### APPEAL SUMMARY

**Status:** Decision Rendered - Reconsideration of ID 20216

<b>Appeal ID:</b> 20501	<b>Project Address:</b> 151 SW 1st Ave
<b>Hearing Date:</b> 6/12/19	<b>Appellant Name:</b> Milena Di Tomaso
<b>Case No.:</b> B-009	<b>Appellant Phone:</b> 5038632425
<b>Appeal Type:</b> Building	<b>Plans Examiner/Inspector:</b> John Cooley
<b>Project Type:</b> commercial	<b>Stories:</b> 5 <b>Occupancy:</b> B, M ,S <b>Construction Type:</b> 3-A
<b>Building/Business Name:</b> PAE Living Building	<b>Fire Sprinklers:</b> Yes - Throughout
<b>Appeal Involves:</b> Erection of a new structure	<b>LUR or Permit Application No.:</b> 19-142823-LU
<b>Plan Submitted Option:</b> pdf [File 1]	<b>Proposed use:</b> Office, Retail

WEST ELEVATION AT PINE STREET MARKET, 126 SW 2ND AVE

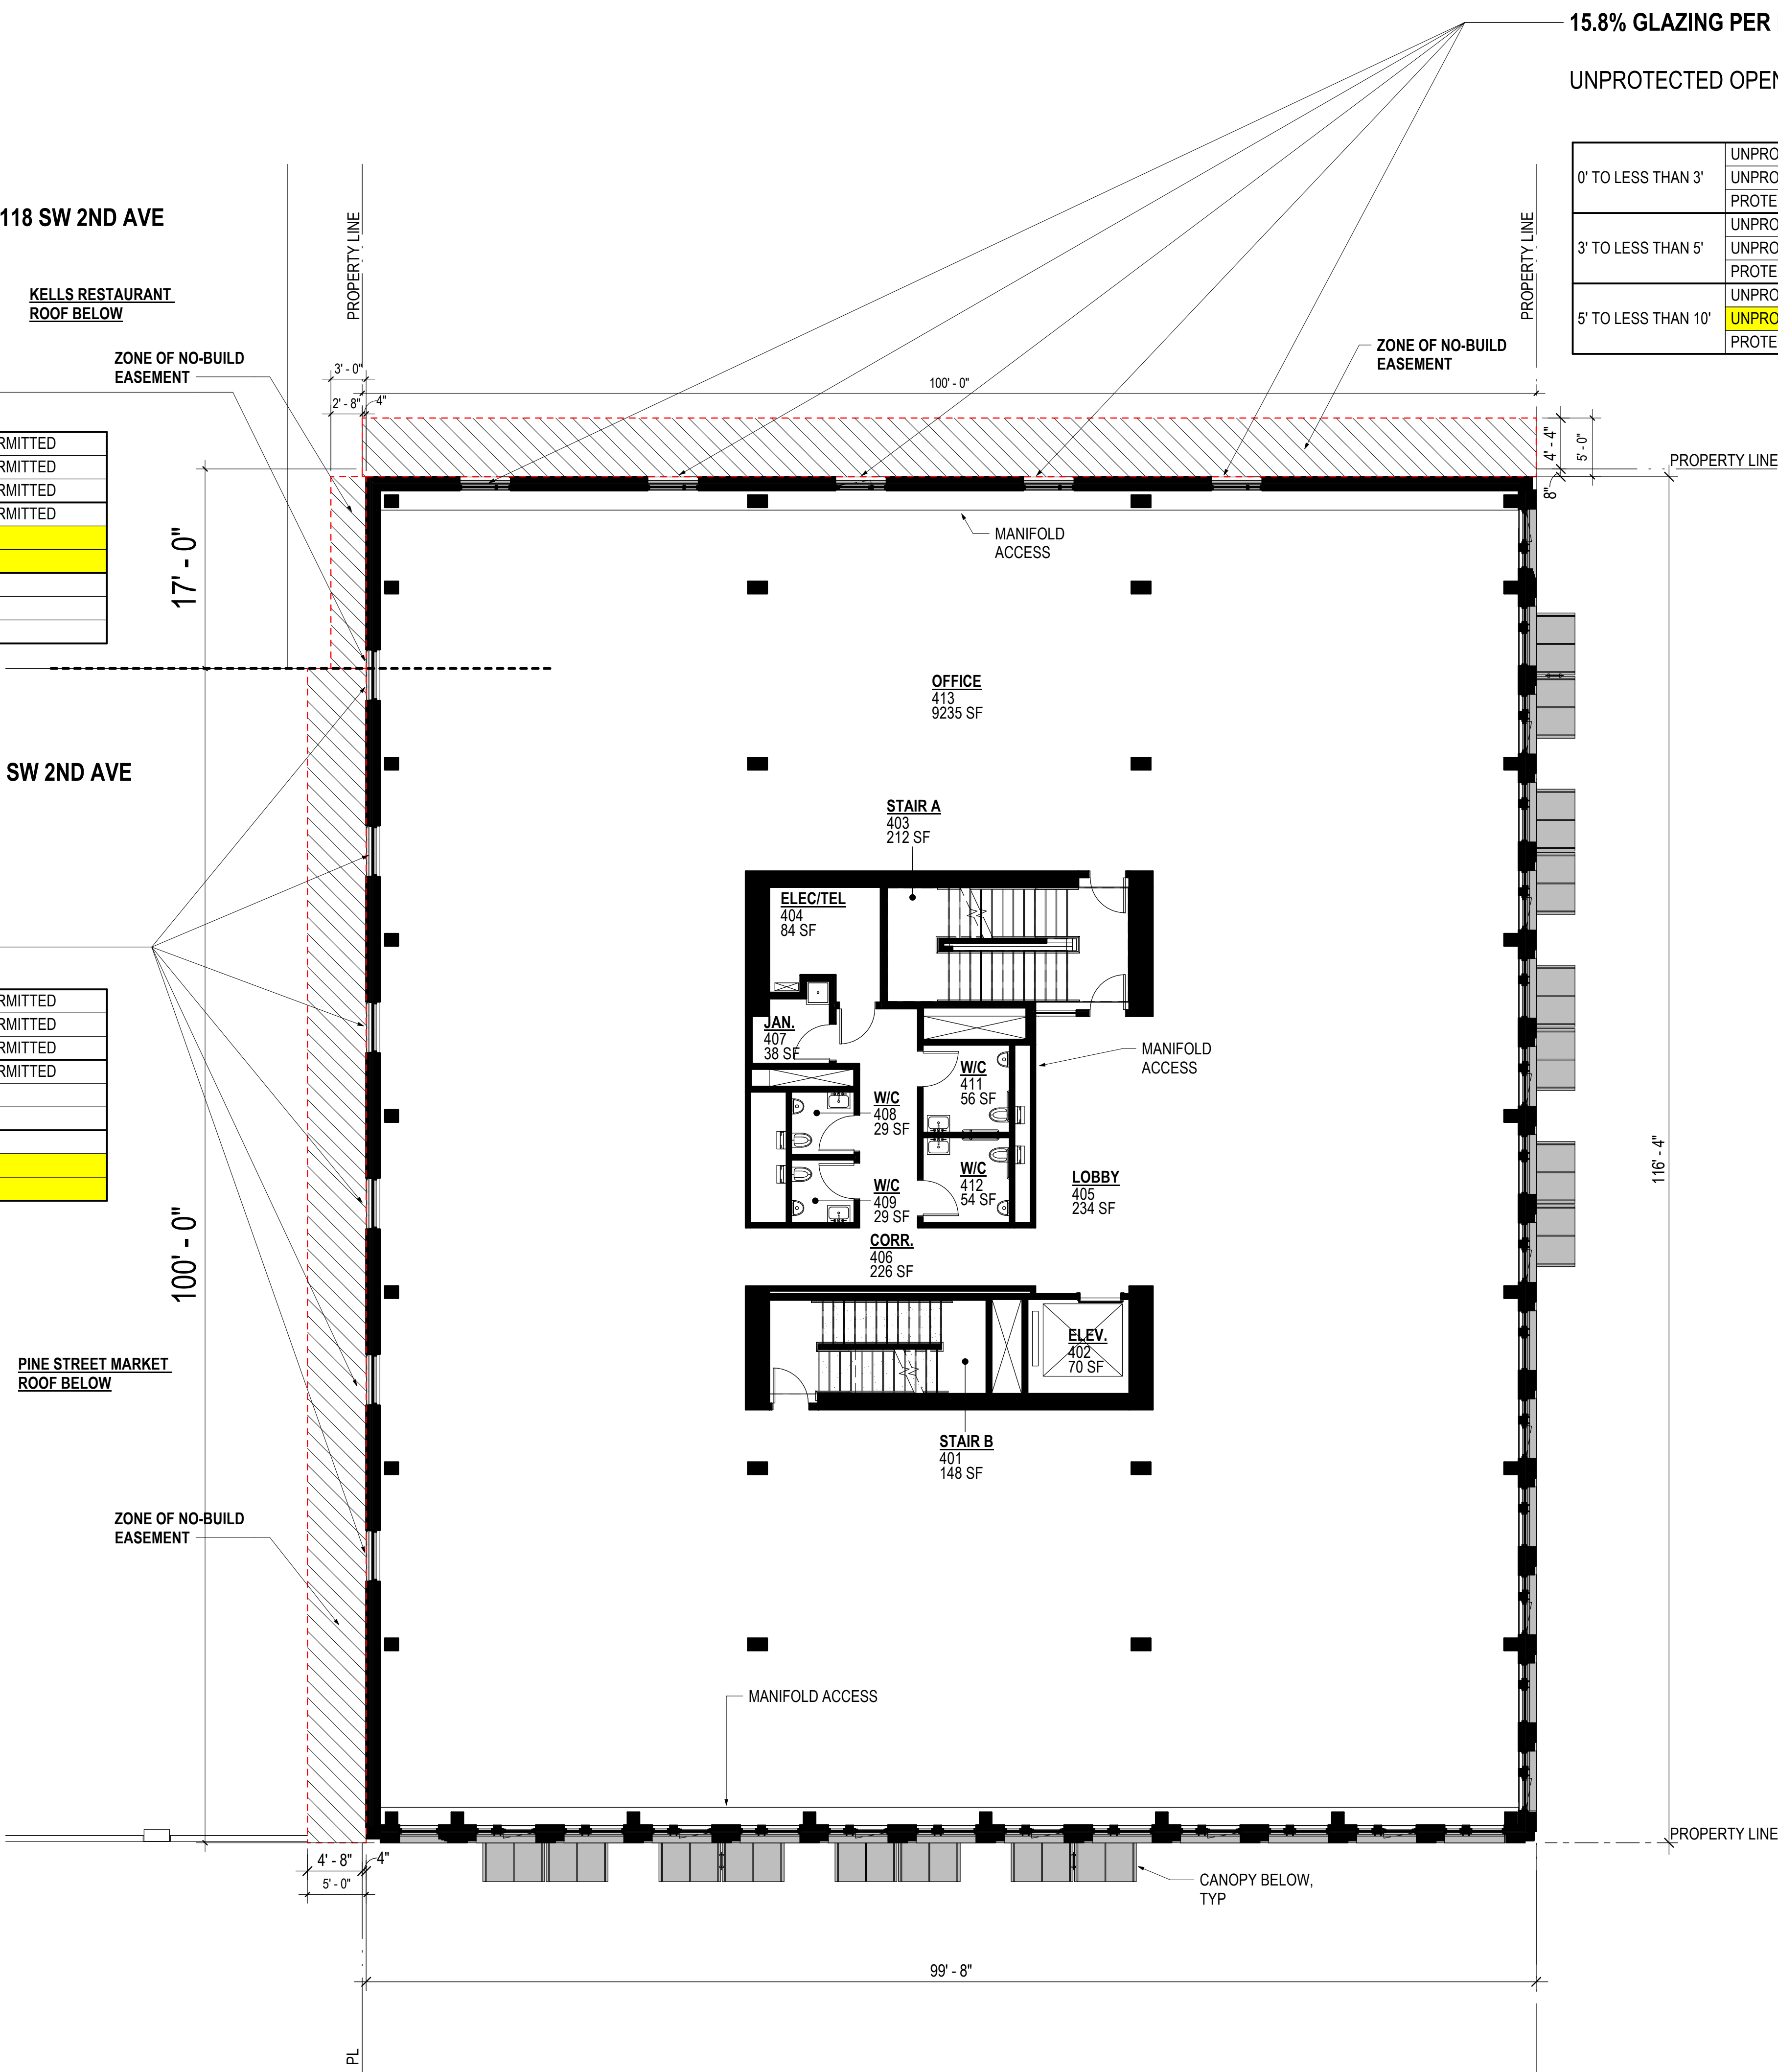
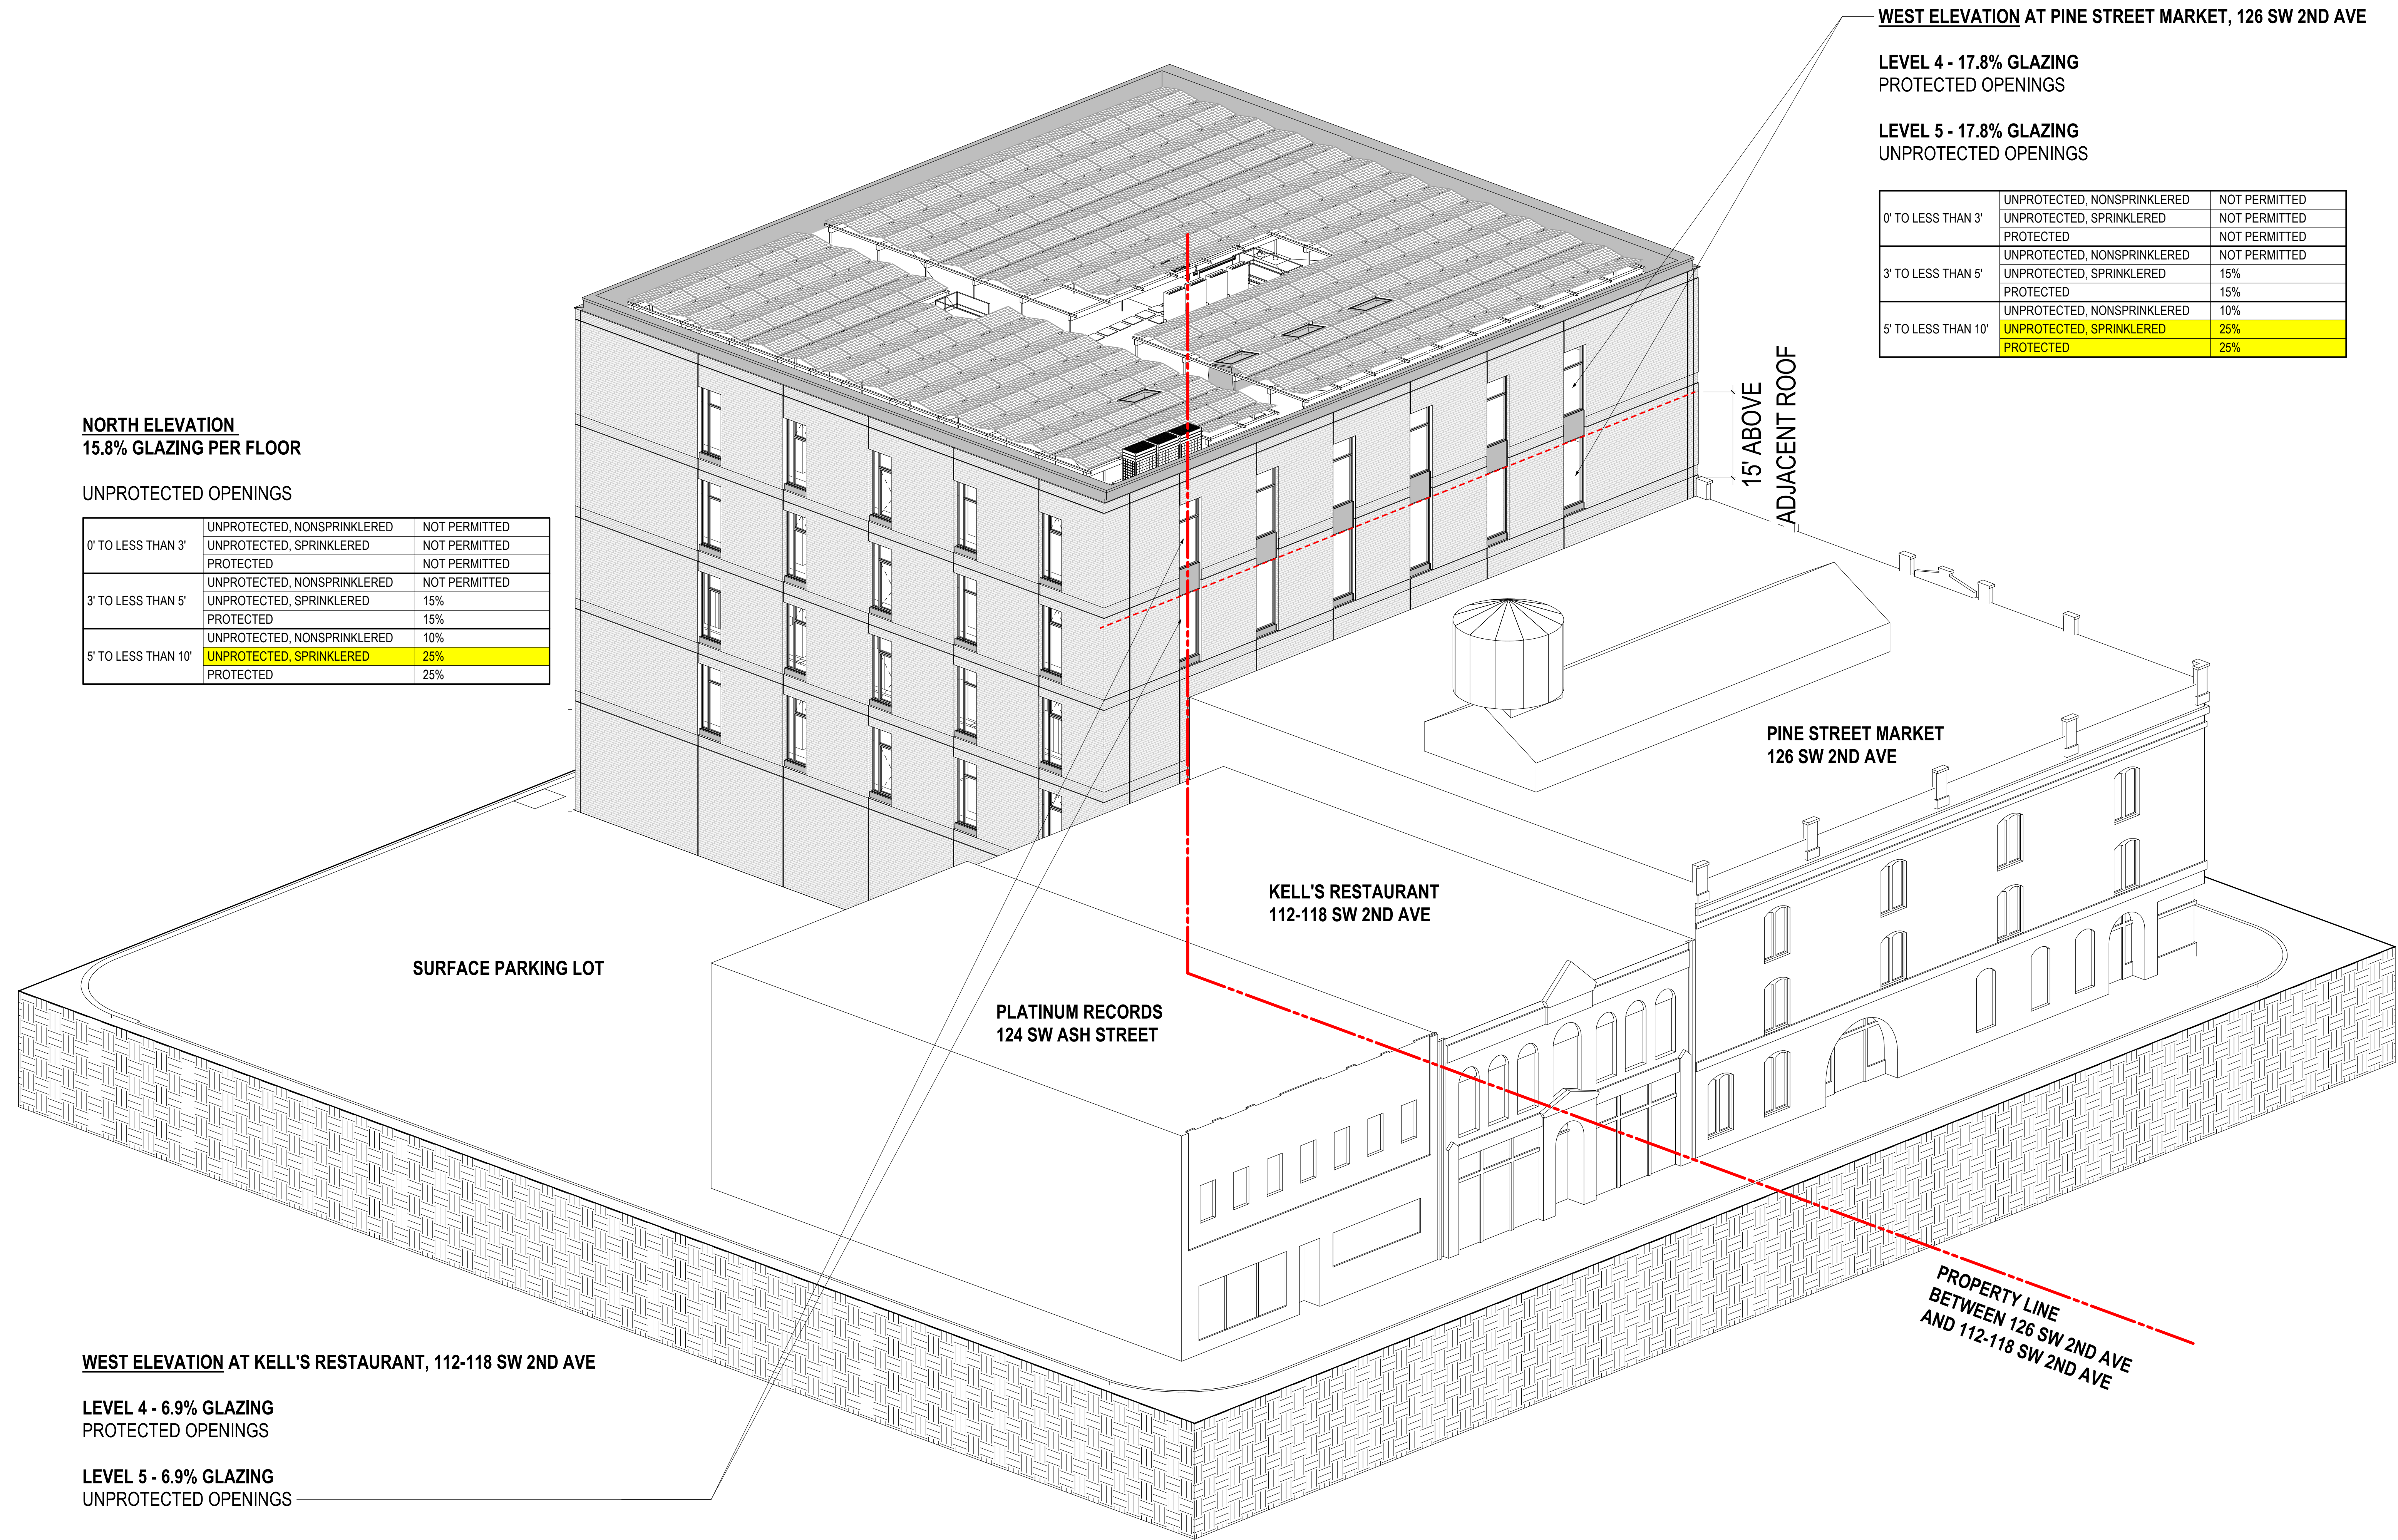
The proposed design locates a total of twenty (20) glazed openings, including both fixed and operable functions, on the second to fifth stories; built on the wall 8" off of the north property line facing the parking lot. A total of twelve (12) glazed openings on the fourth and fifth stories are proposed to be built at the wall located 4" off the west property line. All the openings on the west are proposed to be fixed non-operable windows. Per 705.8.6.2, the west window openings on level 4 are below the 15' vertical distance from the adjacent roof and will require 3/4-hour protection. We are proposing to use a sprinkler head, which is included in a separate appeal with this application.

No-build easements will be established between the north parking lot property, the west Pine Street Market property, and the west Kell's Restaurant property that will prevent any future developments on those lots to occur within the code required fire separation distance. Per Table 705.8, the fire separation distance shall be between 3'-0" and up to 5'-0" when there is up to 15% of unprotected opening area and 5'-0" and up to 10'-0" when there is up to 25% of unprotected opening area in the exterior wall of a sprinklered building. We have less than 25% unprotected openings on both the North and West elevations at Pine Street Market and are proposing a 5'-0" no-build easement as shown on the attached site plan. We have less than 15% unprotected openings on the West elevation at Kell's Restaurant and are proposing a 3'-0" no-build easement as shown on the attached site plan. In addition, a covenant will be established between each of the adjoining properties to state that in the event of a proposed development on those lots, the windows will be removed, and the openings will be infilled with wall construction equivalent to the fire rating of the exterior wall. At that point the no-build easement can be removed to allow the adjacent development.

Note: Three separate easements will be established with the three adjacent property owners. The opening percentage calculations on the west elevation were calculated individually per each shared property line length.

**1b. Openings in the West wall within 3 feet of the property line with no build easement above the roof of the adjacent buildings:** Granted provided the easement is a minimum of 4 feet, 8 inches wide x 100 feet in length for the full length of the adjacent Pine Street Market building and 2 feet 8 inches x 17 feet long adjacent to the Glisan building.
